# Transport Statement

Land at Church Lane, Lydden

20-045-002 Rev B

**Designer's Response to the Stage 1 Safety Audit**

Drawing Title  
Proposed Site Access

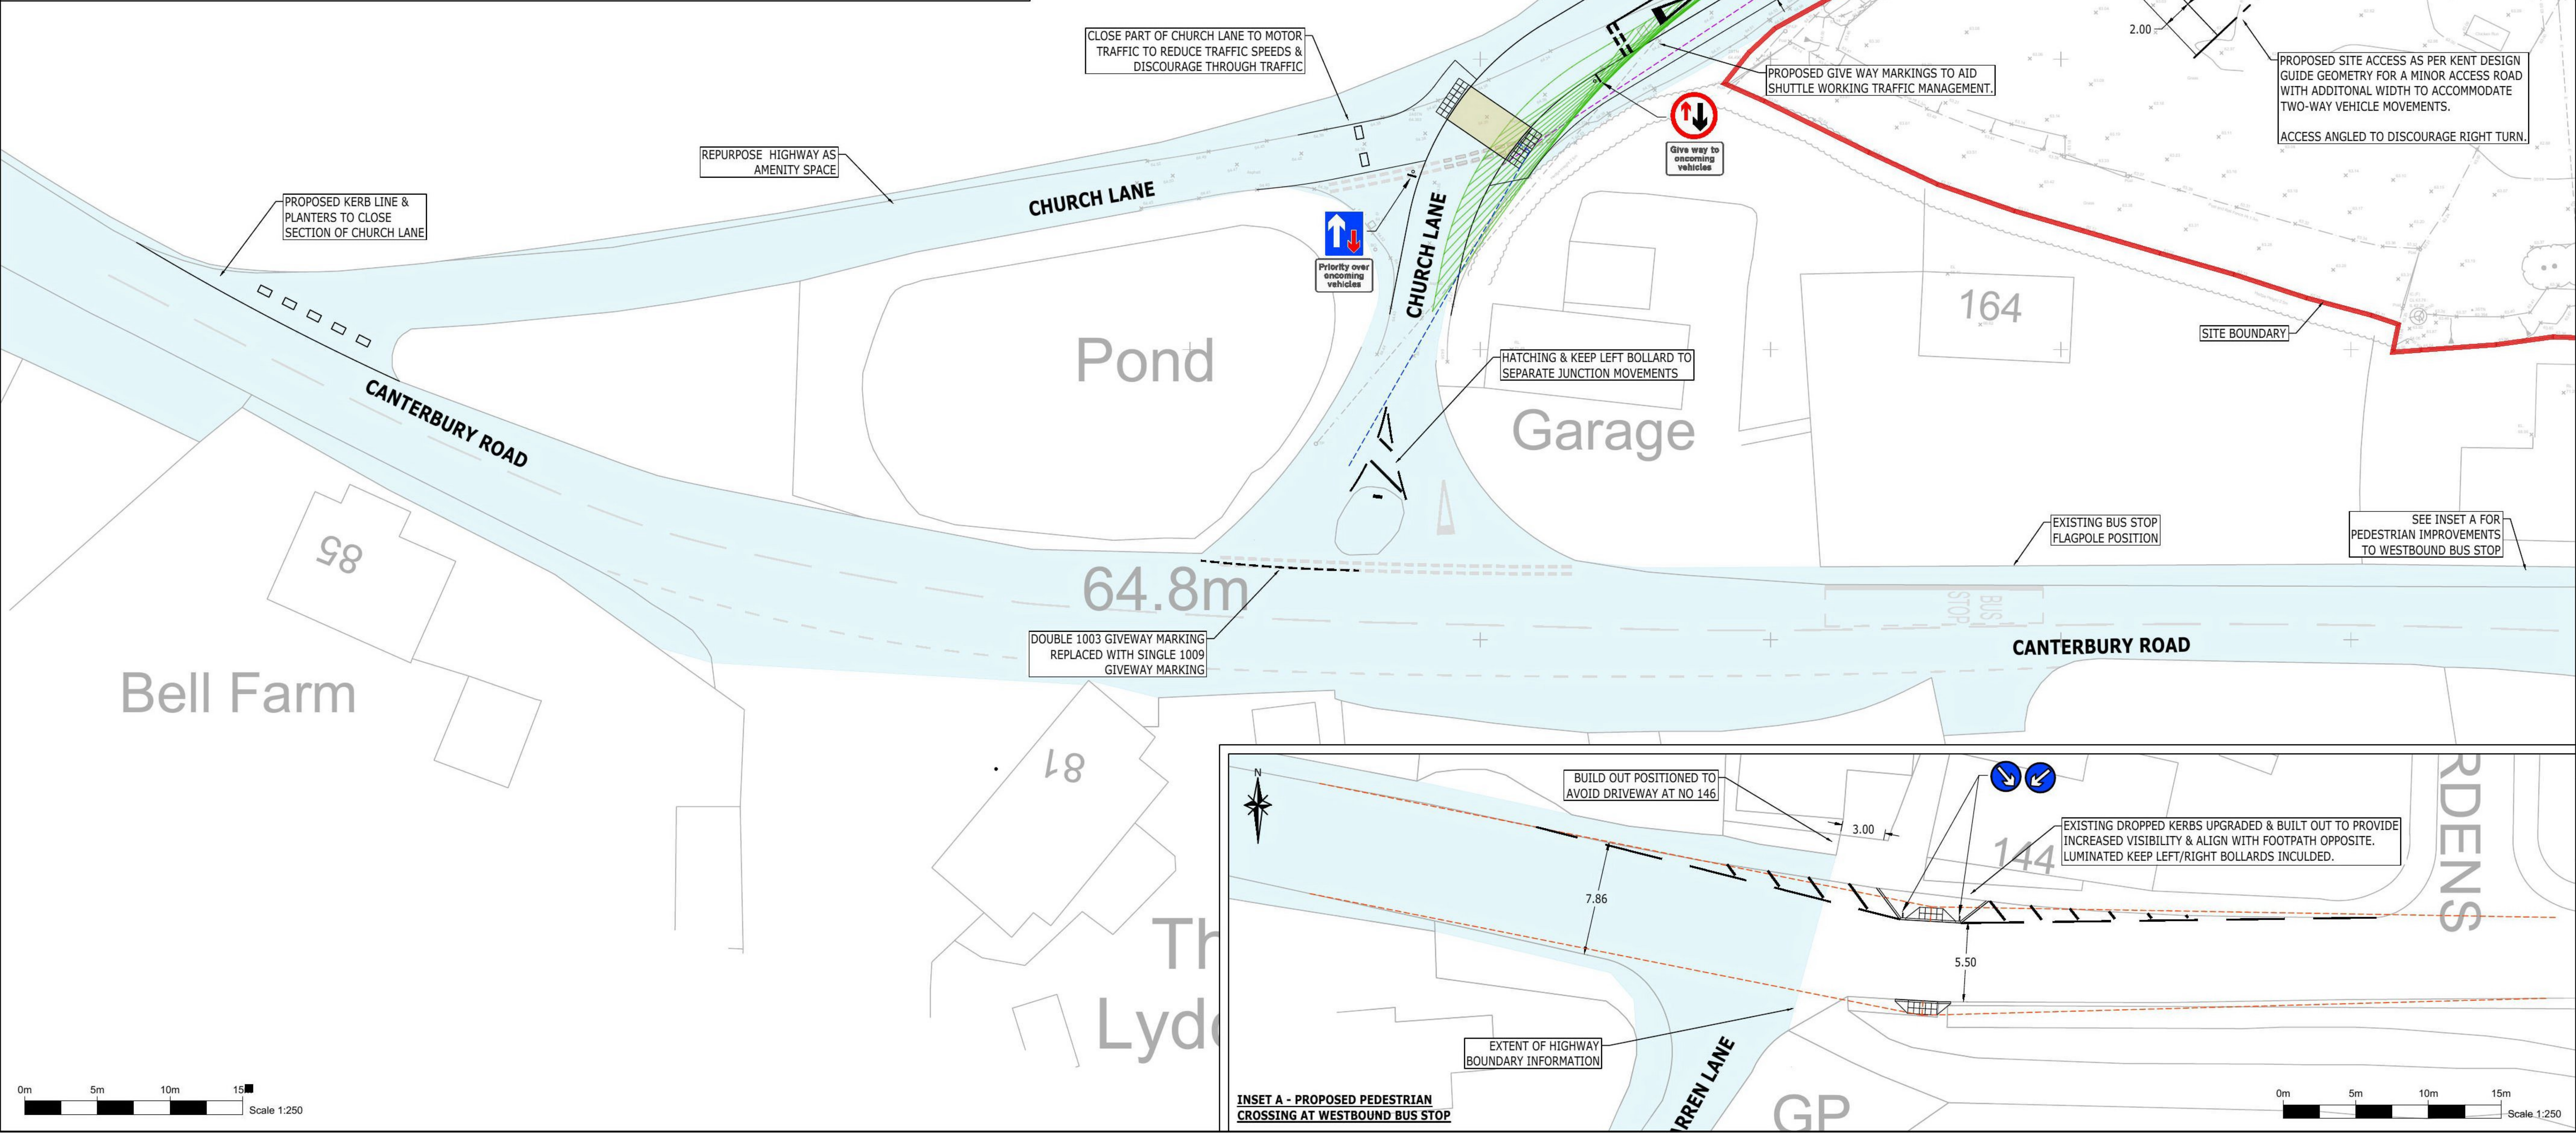
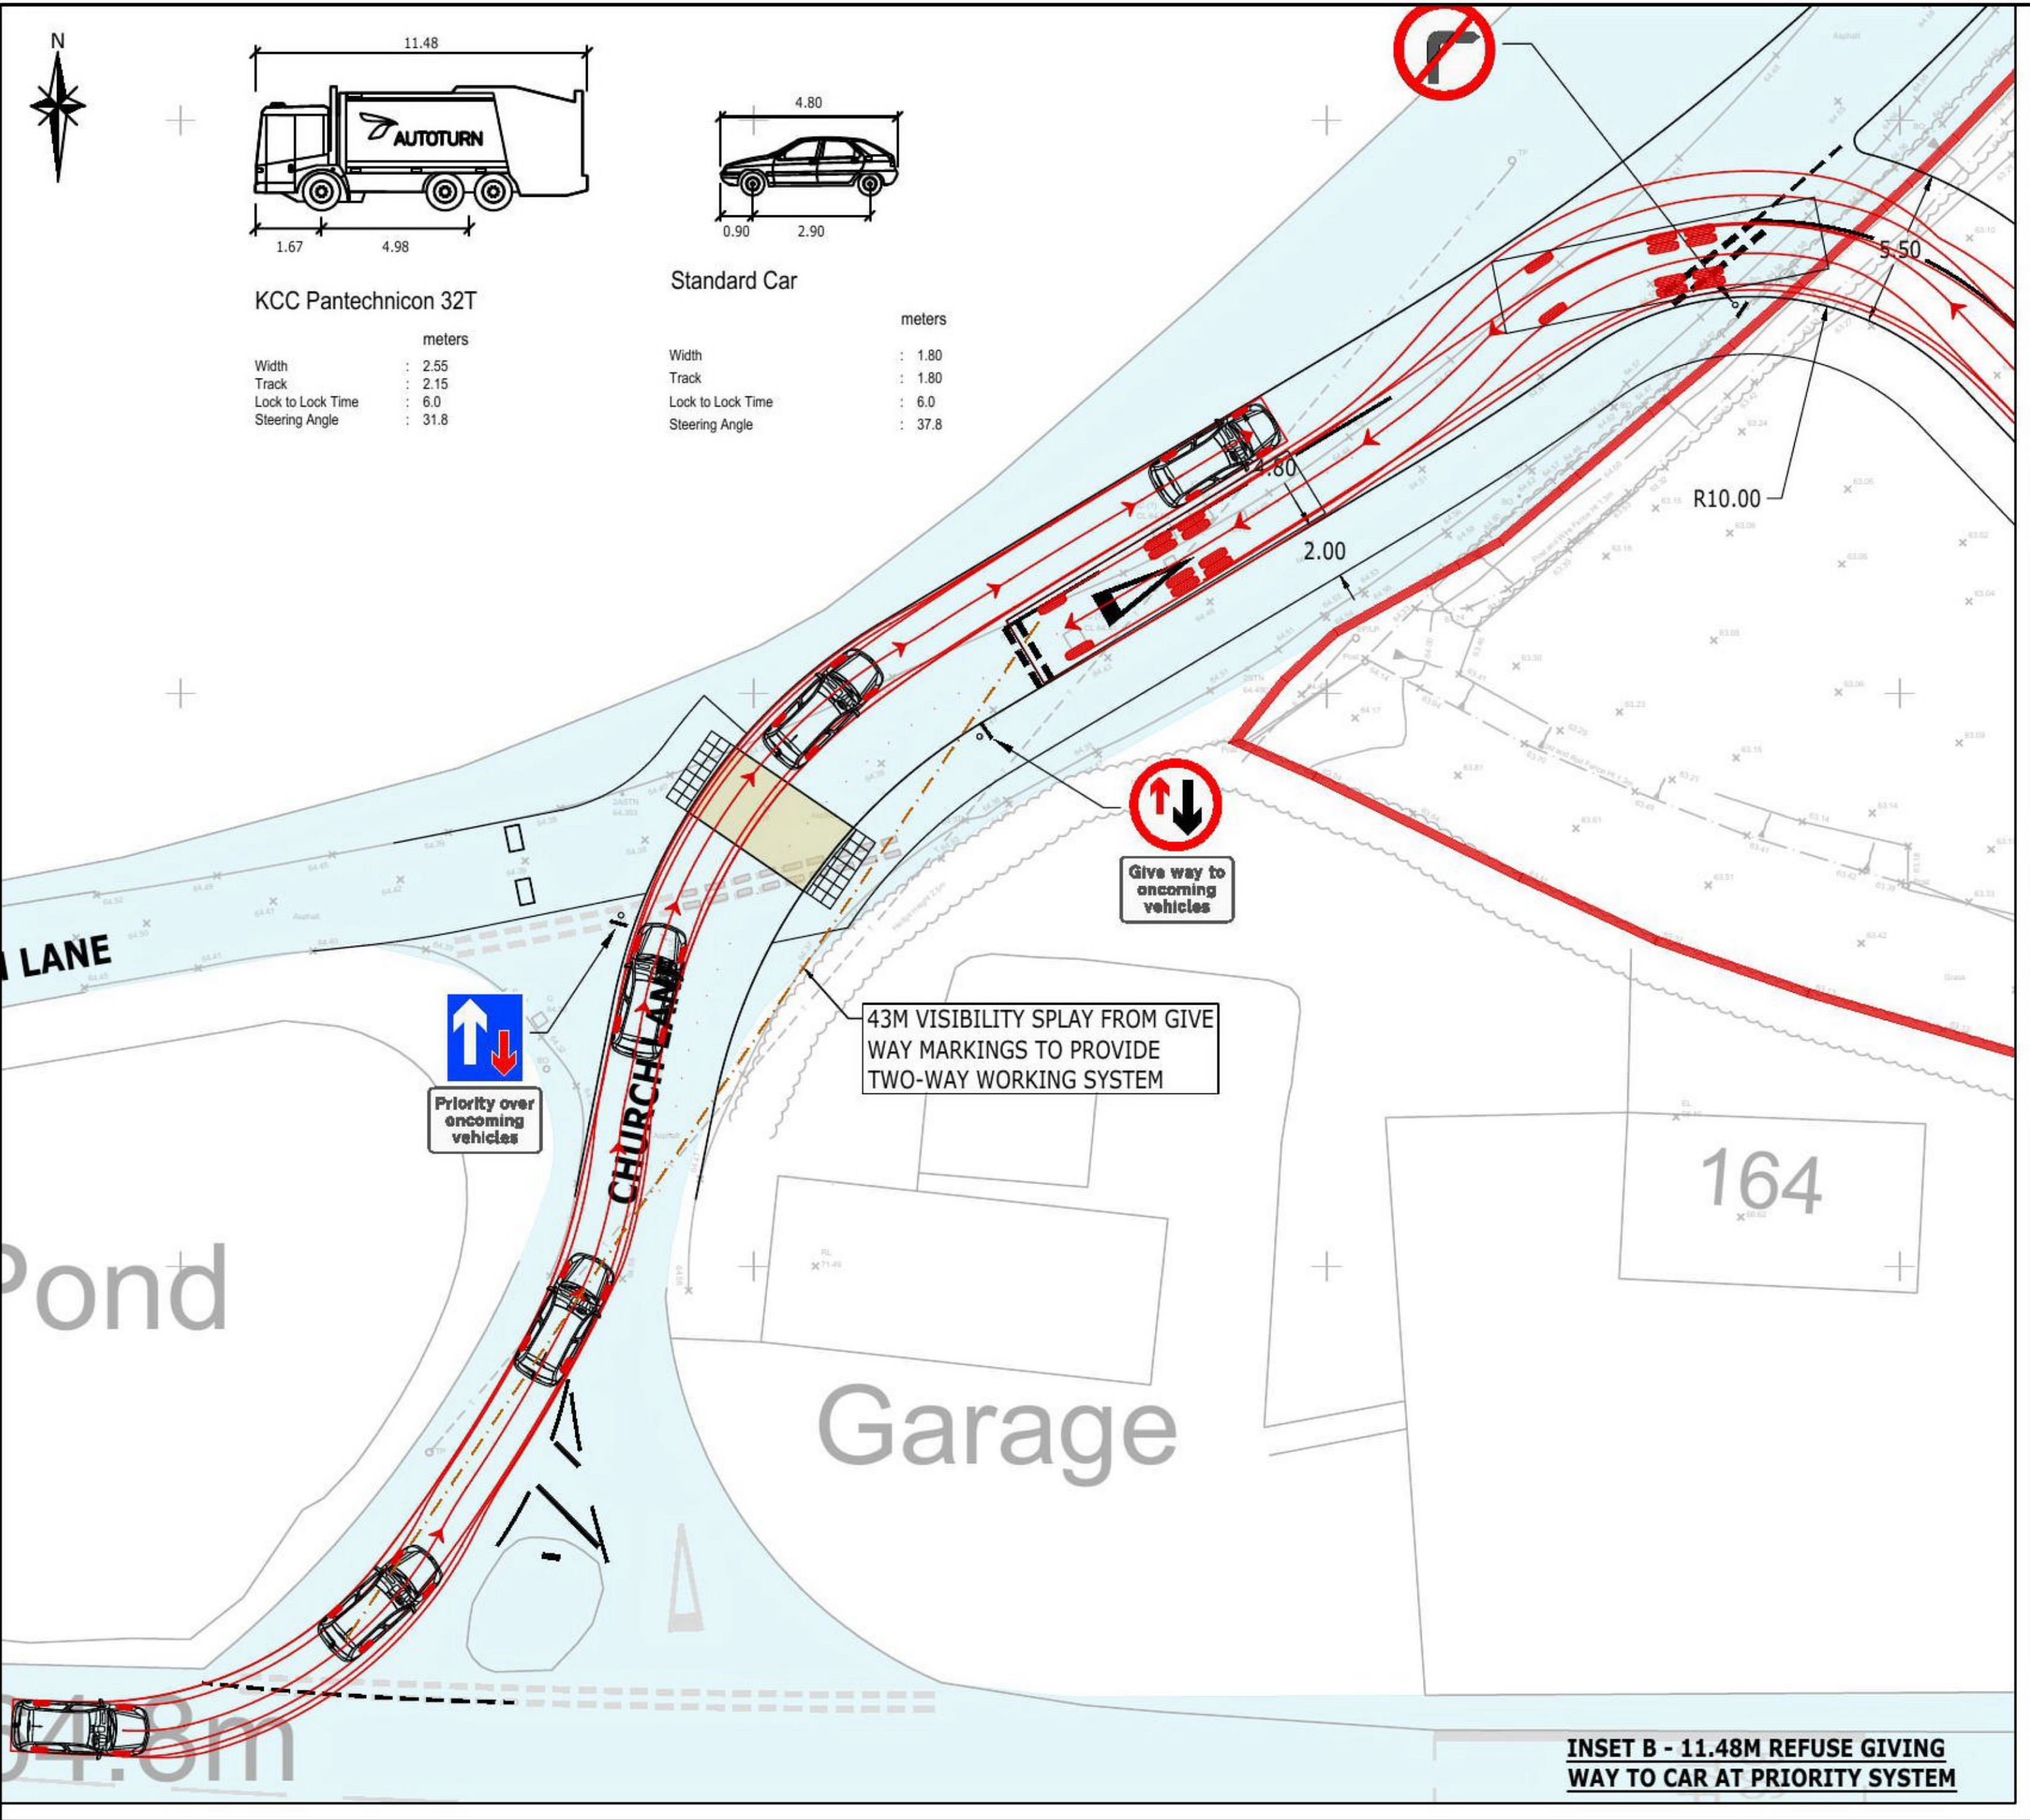
C	Signs added at site access, raised table removed	SH	CG	JW	Aug 23
B	Shuttle working system & additional signage added in response to St 1 RSA	SH	CG	JW	Aug 23
A	Access road widened to accommodate internal layout	SH	CG	JW	Aug 23
Rev	Amendments	Dm	Chk	App	Date
